- **WORKSHOP 3 – review modelling results against your experience**
 - **Task** - Finalise modelling
 - **Task** - Recommendations for management approach
 - **Task** - Investment plan

Aims and Objectives for this Workshop

Comments / questions (1)

Sensitivity of peak flood level in harbour to marsh level

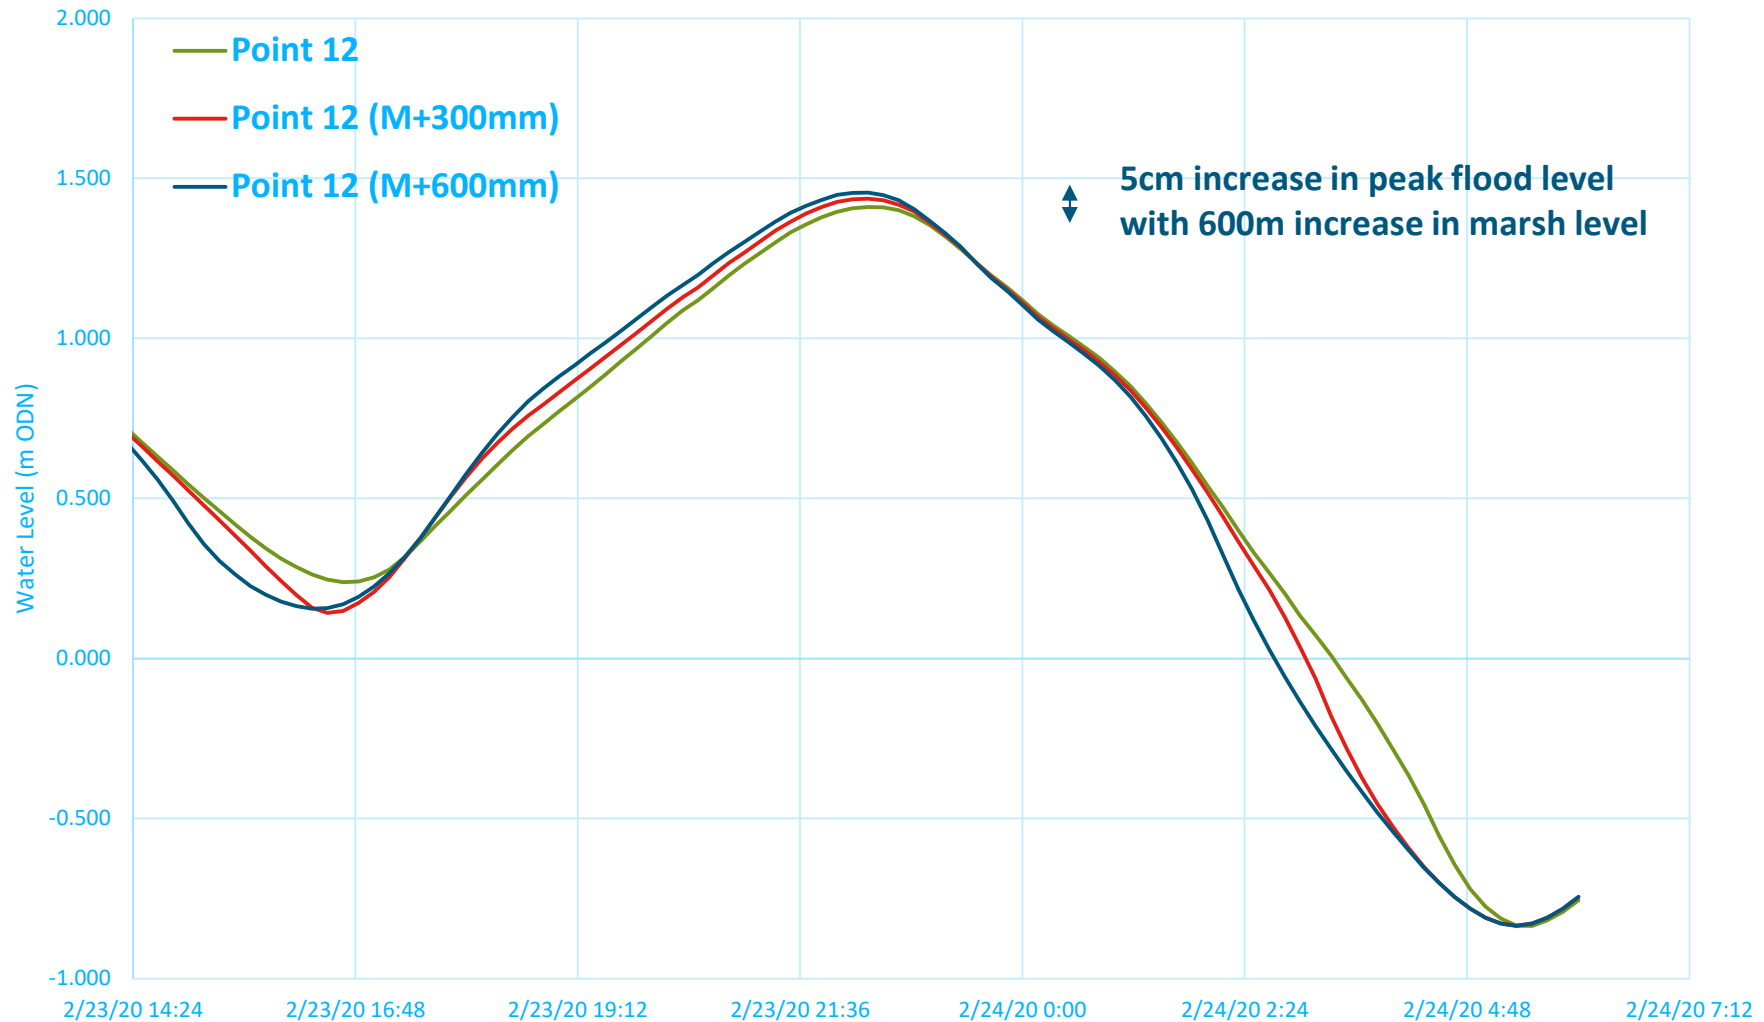
AS18

Correct figure to be added

Sensitivity of peak flood level in harbour to marsh level

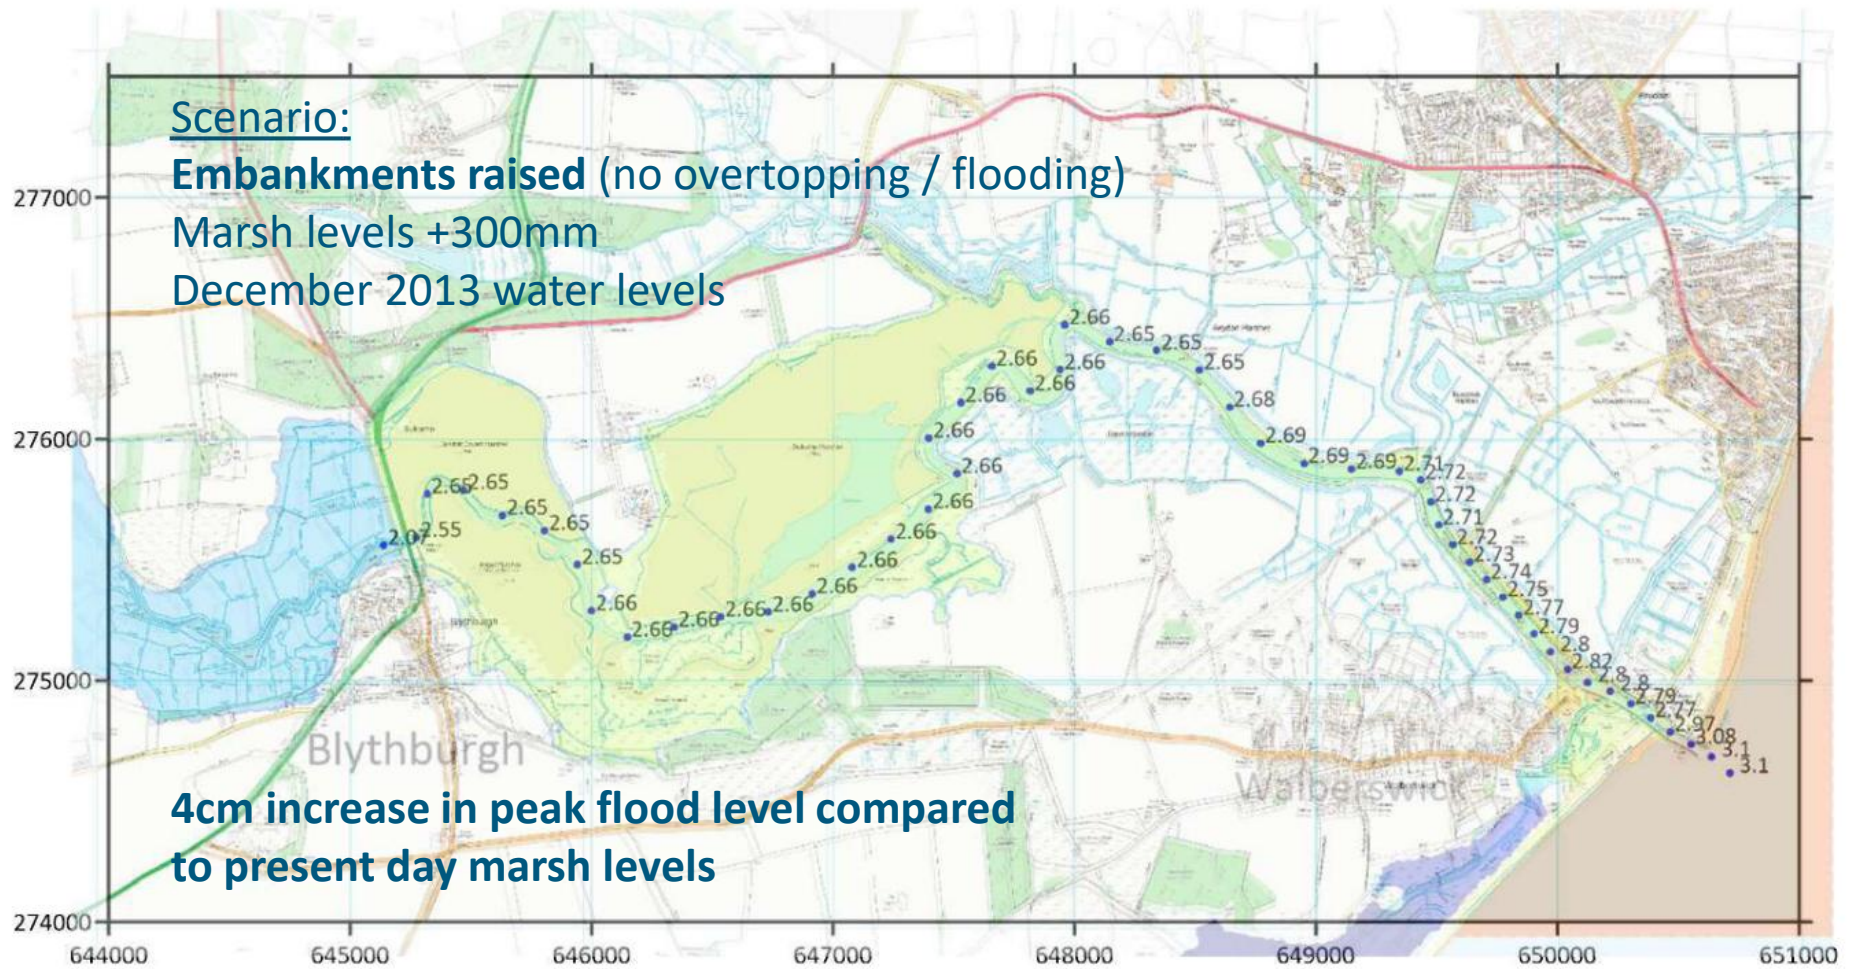
AS19

Correct figure to be added

Sensitivity of peak flood level in harbour to marsh level

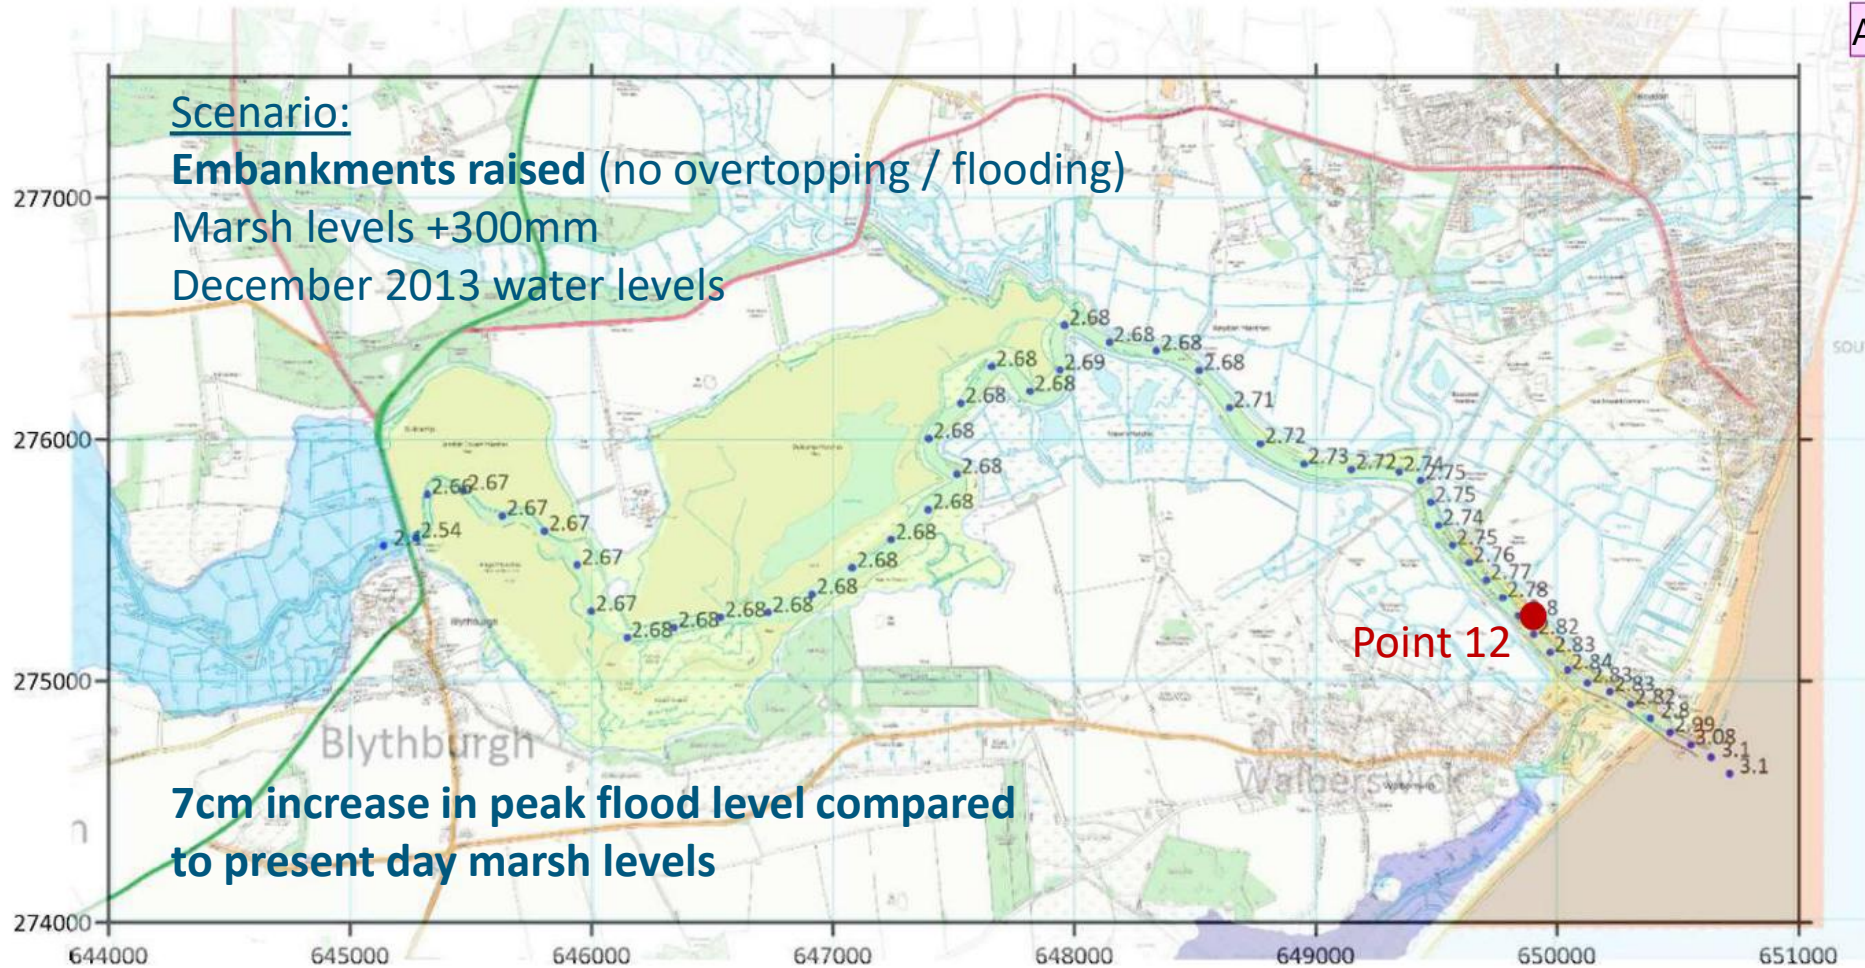
AS20

Correct figure to be added

Sensitivity of flow rate to marsh level

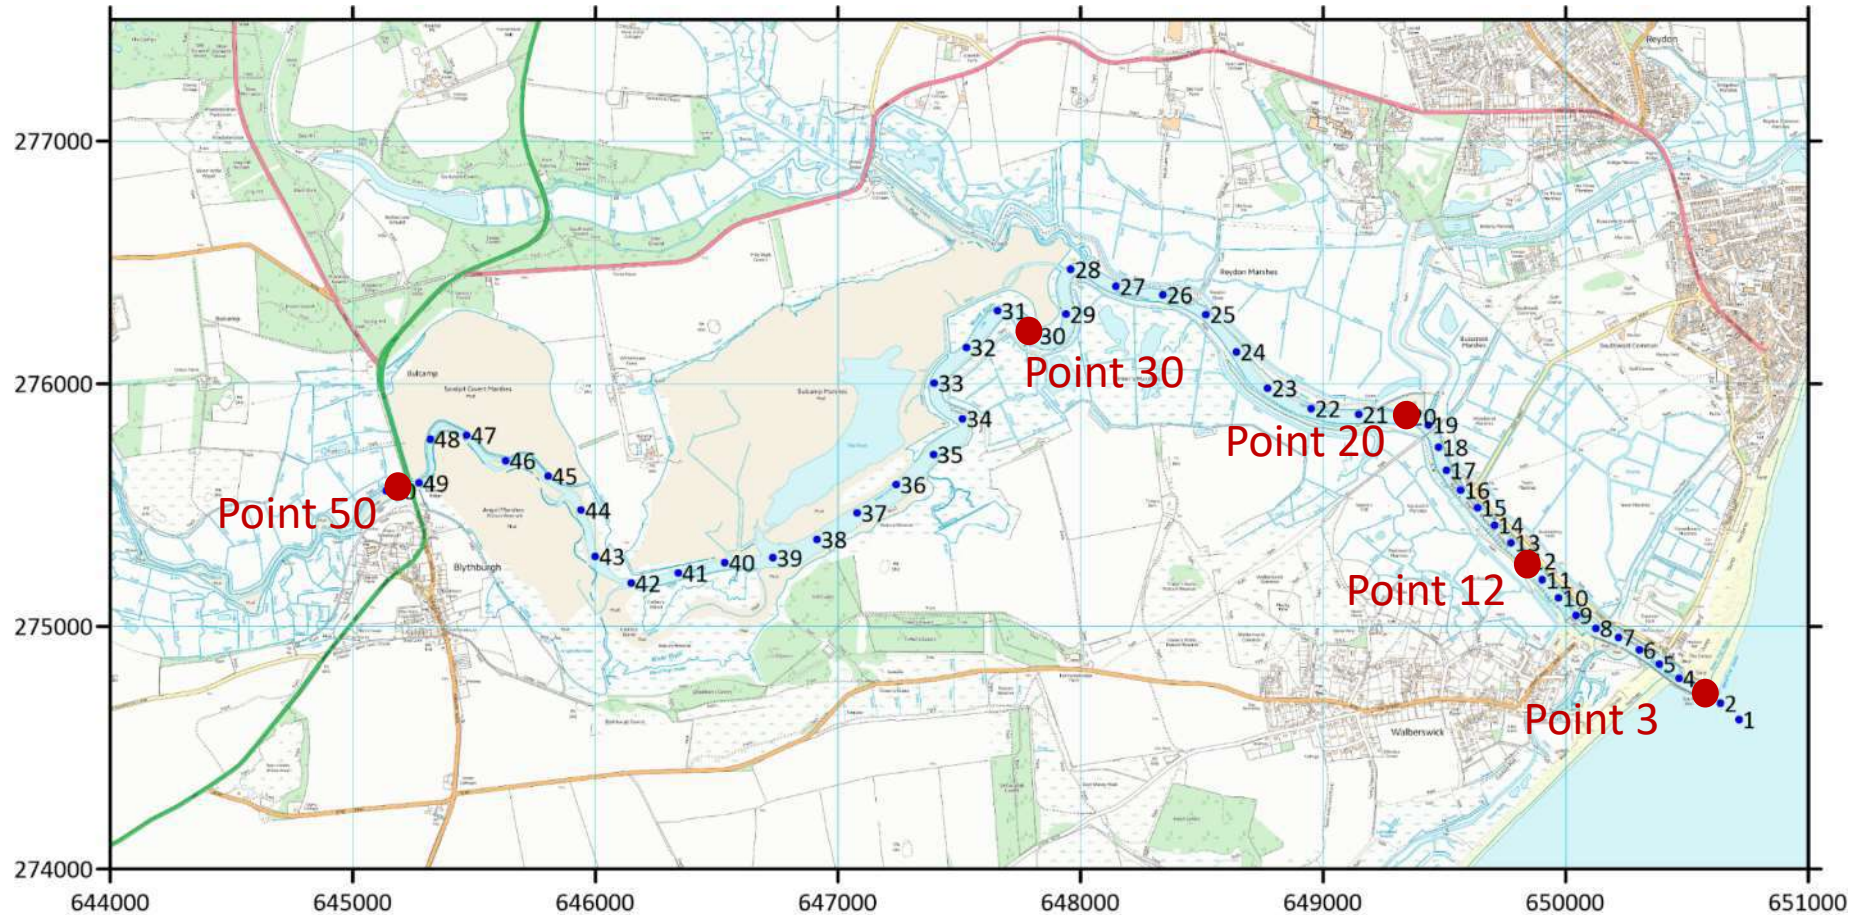
Add results for Dec 2013 conditions, raised embankments
